PANEL REFERENCE & DA NUMBER	PPSHCC-137 DA2022/00538
LGA	City of Newcastle (CN)
PROPOSED DEVELOPMENT	Mixed Use Development - Shop top housing, comprising commercial premises (4), carparking (171), podium level, and residential (106) units.
STREET ADDRESS AND OWNER DETAILS	Lot: 1 DP:1166015 643 Hunter Street Newcastle West
APPLICANT	ADW
OWNER	Next Level Seven Pty Ltd
DATE OF DA LODGEMENT	20 May 2022
APPLICATION TYPE	Local
REGIONALLY SIGNIFICANT CRITERIA	<p>The application is referred to the Hunter and Central Coast Regional Planning Panel ('the Panel') as the development is 'regionally significant development', pursuant to Section 2.19 and Clause (2) of Schedule 6 of the State Environmental Planning Policy (Planning Systems) 2021 as the proposal is a general development that has a capital investment value of more than \$30 million.</p> <p>The application submitted to Council nominates the capital investment value of the project as \$49,590, 708 (excluding GST)</p>

This supplementary report provides further information in response to matters raised during the determination meeting and provides associated amended conditions of consent. The supplementary assessment should read in conju

Figure 3: Image identifying view access and surrounding buildings existing, approved, and proposed UDRP heights.

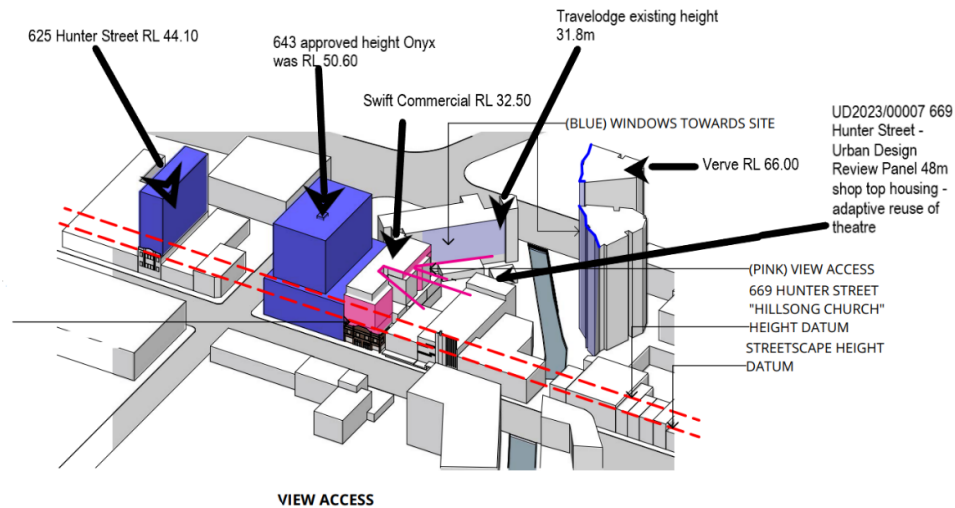
The Verve building has its primary outlook to the north-east, south-east, and south-west. General outlook to the south-east and south-west will remain unaffected, however several upper-level apartments with north-easterly views toward the site will be impacted.

In relation to the views from the Verve, this assessment confirms that the proposed built form of the subject development will impact on the views toward the harbour, Nobbys Headland, and the city centre. However, it is noted that the height controls within the NLEP 2012, in combination with City Centre provisions under NDCP 2012 enable this built form, accordingly it is considered that the proposed height does not contribute to unexpected or unreasonable view loss impacts given the its location within the City centre.

When considered in the broader context of the Newcastle City Centre and the State Government targets for housing and employment, amendments to facilitate the retention of regional and distinct views are not considered to be reasonable.

Given the building's level of general compliance, the loss of views experienced by The Verve is a reasonable and expected outcome. Existing views from all surrounding properties are considered borrowed views and outlook, across the subject site which benefits from a prescribed 60m height. Both 'The Verve' and the subject application benefitted from Part 7 of the NLEP and the 10% design excellence uplift which permits a building height of 66m. The city centre is an area undergoing transition and the proposal in its current form achieves the desired future character for the area. Whilst the view impacts are noteworthy, this is an expected outcome for a locality progressing towards an anticipated and desired transition as a consequence of increasing density in a city centre. It is noted that the built form and height have been determined as a result of a detailed design process which has allowed for effective integration between the existing and proposed built form. It is considered that the development will have a positive impact upon the setting of the site and streetscape, the development achieves design excellence, and its construction will assist in rejuvenating the area.

Figure 4: Newcastle LEP Land Use Map – Pink identifying the 60m height limit (The Verve site highlighted in blue).

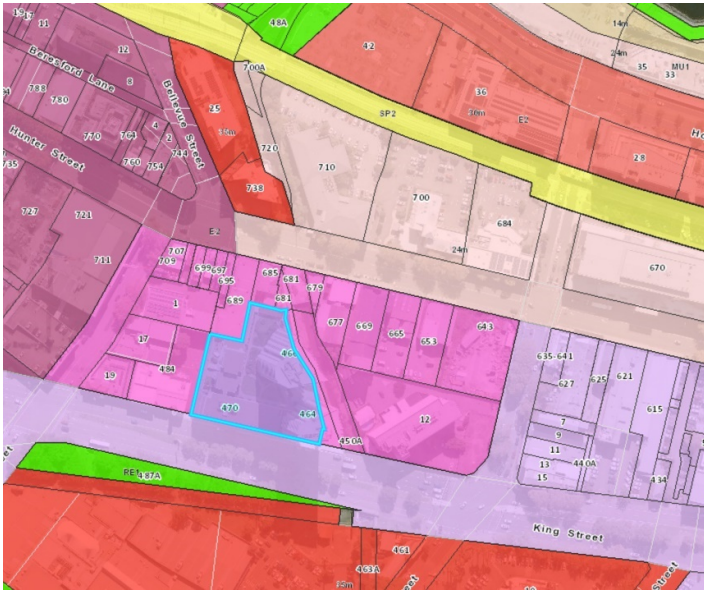
Section 6.01 Newcastle City Centre of the DCP sets the desired future direction for the locality, and it is considered likely that in some form heights and density across the city will be increased in the future. Figure four identifies the prescribed building height under the Newcastle LEP 2012.
